AGENDA CITY OF CEDAR FALLS, IOWA PLANNING AND ZONING COMMISSION MEETING WEDNESDAY, OCTOBER 14, 2020 5:30 PM AT CITY HALL VIA VIDEO CONFERENCE

MEMORANDUM

- DATE: October 8, 2020
- SUBJECT: Land Use Map Amendment (LU20-003) Rezoning Request 4800 Block Cedar Heights Drive Oster Property (RZ20-002)
- REQUEST: Amend Future Land Use Map to reflect Planned Development Rezone property from A-1, Agricultural District and R-1, Residential Zoning District to MU, Mixed Use Residential Zoning District.
- PETITIONER: Oster Family Limited Partnership

Street network and traffic circulation

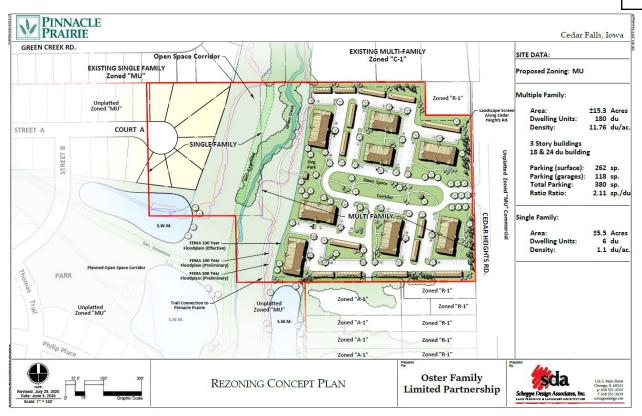
The 2015 master plan illustrates the roadway alignments, access locations and proposed intersection designs and locations for the major streets within the development (Prairie Parkway, Oster Parkway, Viking Road, and a portion of Prairie View Road. Other potential streets connections are also illustrated, but additional local streets are just conceptually shown with arrows. Lots and blocks are not illustrated so it is difficult to understand how the neighborhood would be laid out with a local street pattern, and how the trails, parks, and stormwater management areas would be located in relation to the streets. Staff requested that the applicant submit a more detailed concept plan showing the streets, blocks and potential lots, so one can clearly see how the neighborhood could function as a whole. This preliminary work will be a precursor for the subdivision platting, which will be required prior to sale of any portion of the development, including the multi-family area proposed for rezoning.

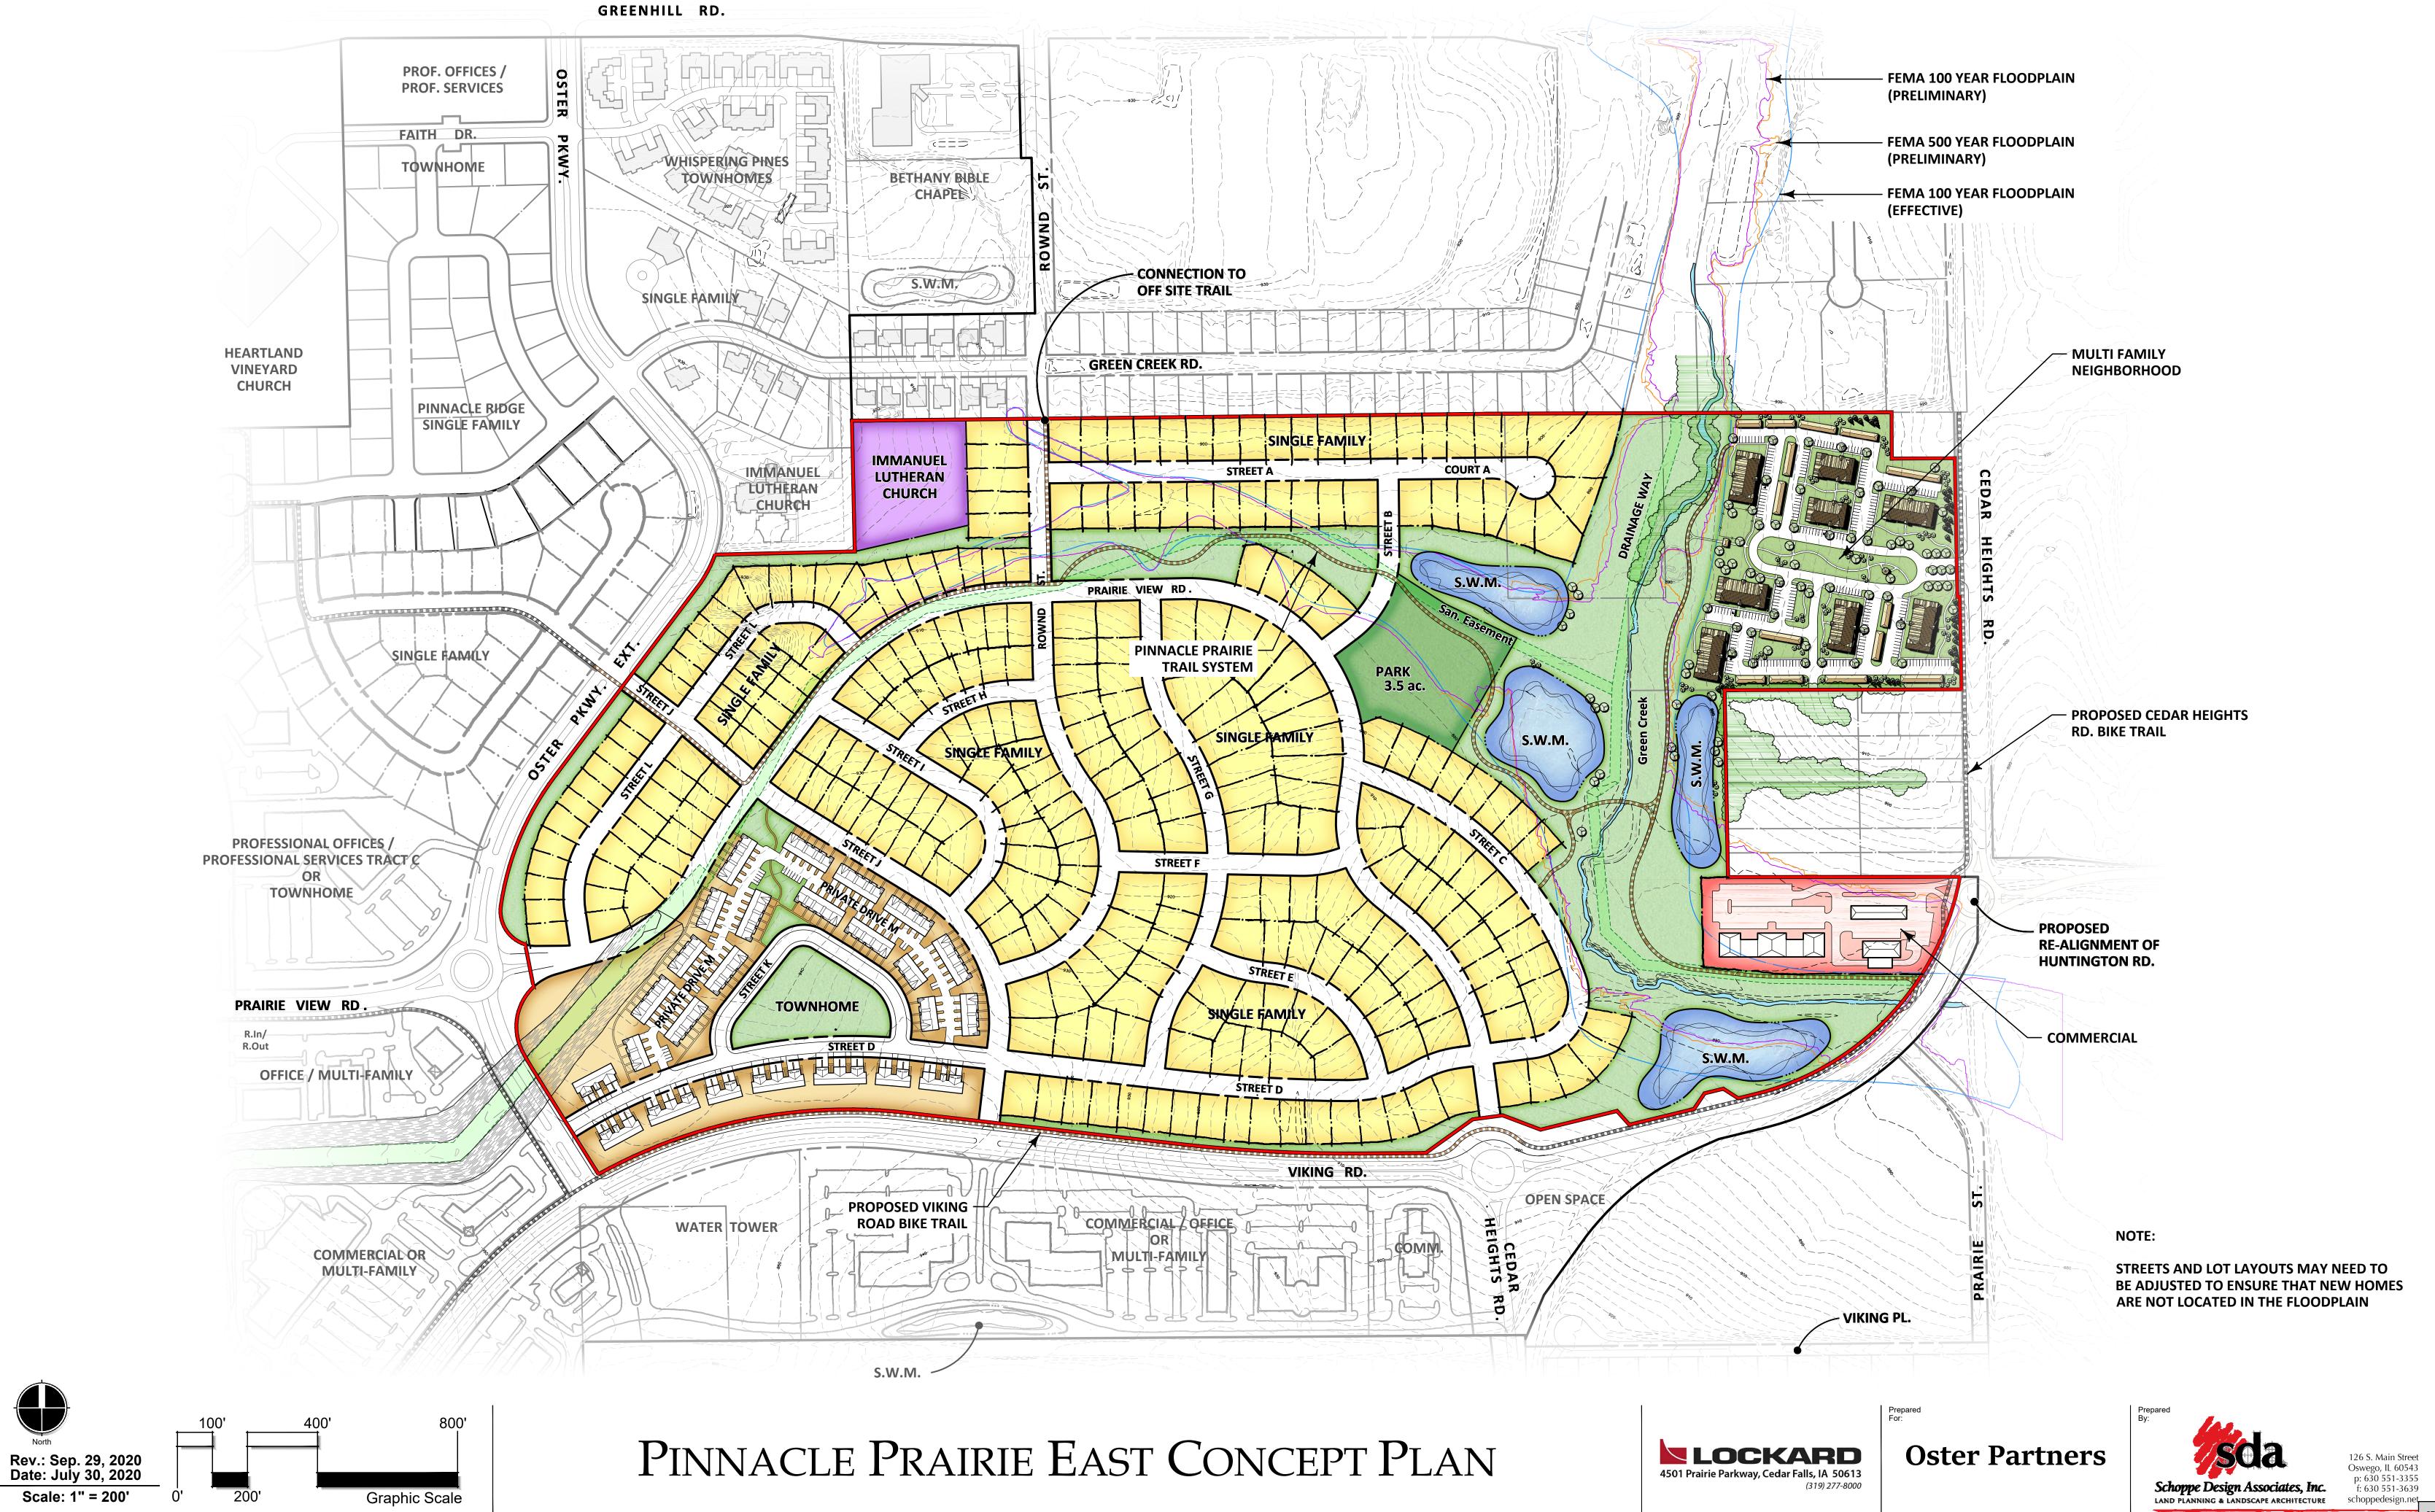
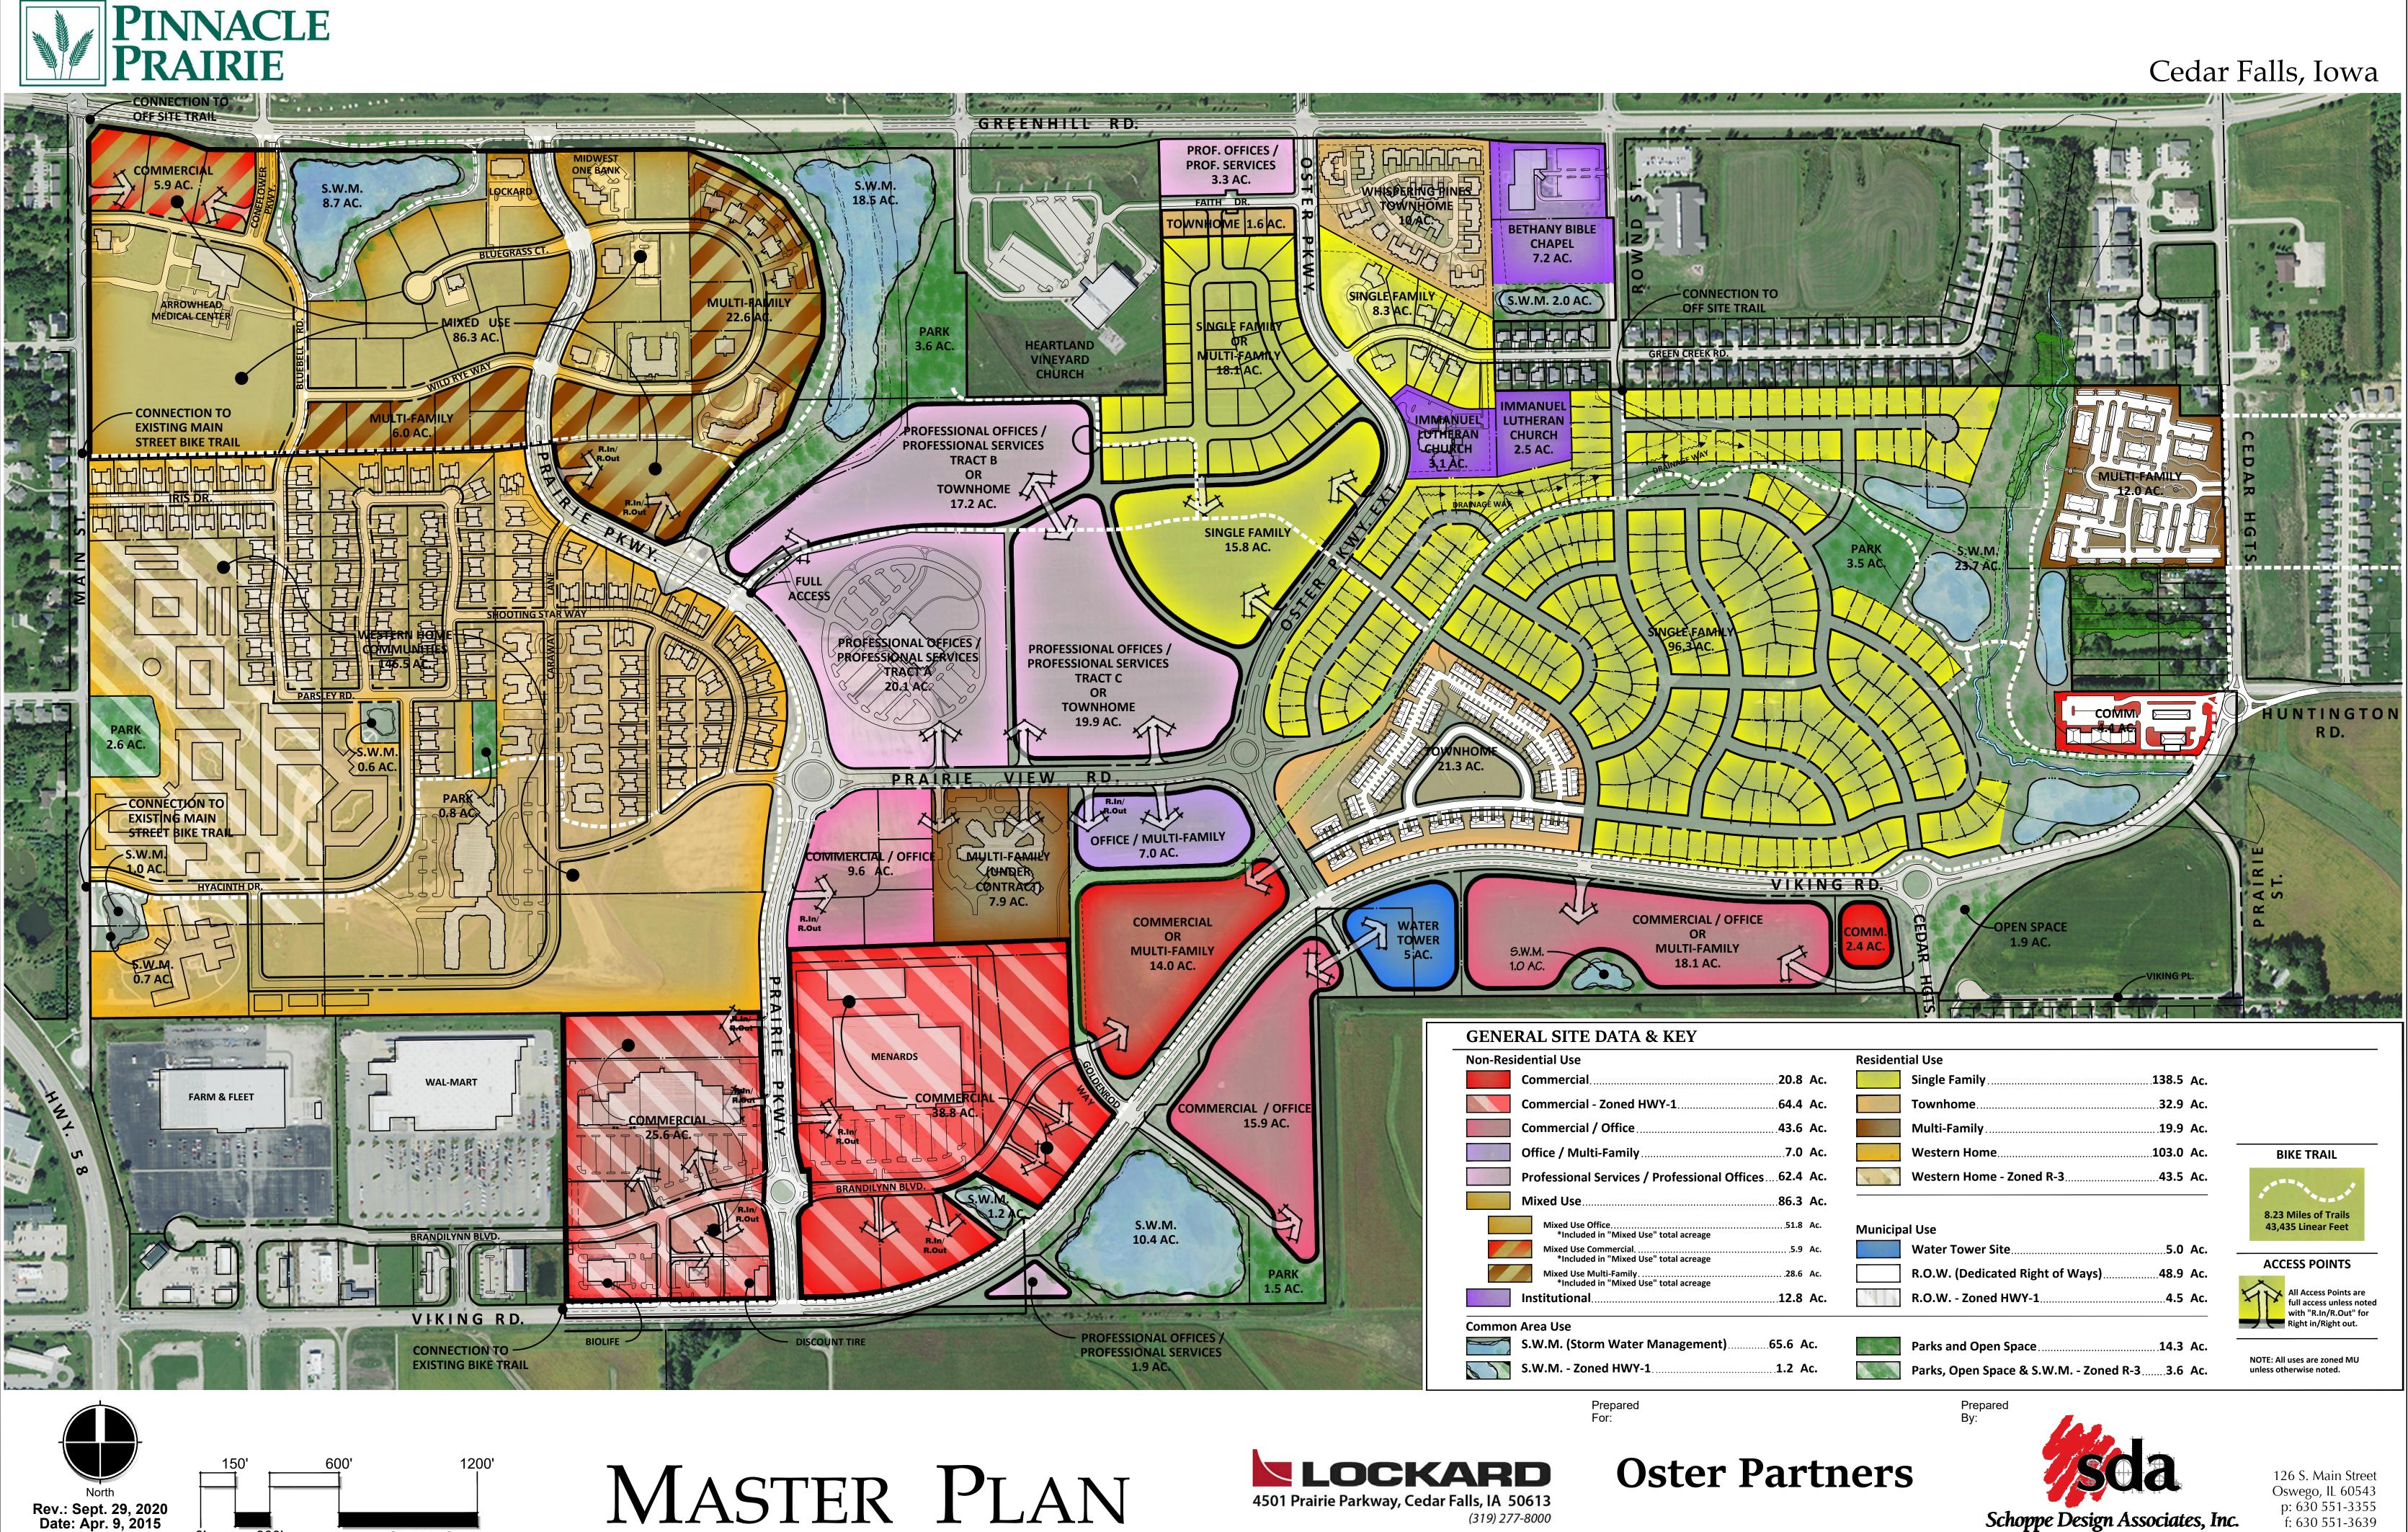
- With the proposed change to the master plan, there would be <u>no</u> east-west street connections to Cedar Heights Drive from the entirety of the Pinnacle Prairie development, with the distance between Greenhill Road and the intersection at Viking Road over 4,000 feet. Staff finds this problematic for a number of reasons:

- For safe and adequate traffic circulation within and between neighborhoods it is important to provide collector street connections along arterial streets at intervals of about ¼ mile (1320 feet) with additional right-in, right-out access points strategically placed in between collector streets. The amended master plan falls far short of that mark and eliminates the one connection previously shown on the 2015 Master Plan.

- The 2015 master plan illustrates a single family area along Cedar Heights with an arrow indicating that this area would be connected with a street to the larger Pinnacle Prairie neighborhood. The rezoning request represents a considerable up-zoning from the adopted master plan (which would have yielded approximately 24-30 single family dwellings) to medium to high density multi-family development which would yield approximately 180 dwelling units, making an east-west street connection even more critical to serve the needs of these additional future residents. The economics of extending the street across Green Creek will improve with the proposed up-zoning, so there should be no reason to eliminate this street connection from the Pinnacle Prairie Master Plan.

- With the number of units proposed two means of access should be provided to serve this area for public safety purposes. To provide some context, the International Fire Code includes a standard that no more than 30 single and duplex dwelling units should be allowed on a single means of access to ensure adequate access in case of emergency. The applicant proposes an up-zoning that would allow approximately 180 dwelling units with just one means of access. Keep in mind that connecting the street will improve emergency access for the single family area as well. In general, the more travel routes, the lower the emergency response time for fires and other emergencies.

- As proposed, the multi-family area would be isolated from the rest of neighborhood without good access to important north-south street routes, including Oster Parkway, Rownd Street, and Prairie Parkway and associated office and employment areas along these streets. Equally as important, this connection will provide a critical connection to Cedar Heights Drive for residents within the entire neighborhood.

One option for creating an east-west street connection is to eliminate the cul-de-sac, labelled as "Court A," by extending it to the east through the multi-family area to Cedar Heights Drive. This would follow the alignment of a farm access road that previously extended across the creek. There may be other options that also could be explored, such as reconfiguring the street and lot pattern to route Prairie View Road to connect with Cedar Heights Drive.

The applicant has not modified the proposed concept plan to include an east-west street connection to Cedar Heights Drive. <u>Therefore, staff recommends denial of the rezoning request</u> and amendment of the Pinnacle Prairie Master Plan as proposed by the applicant.
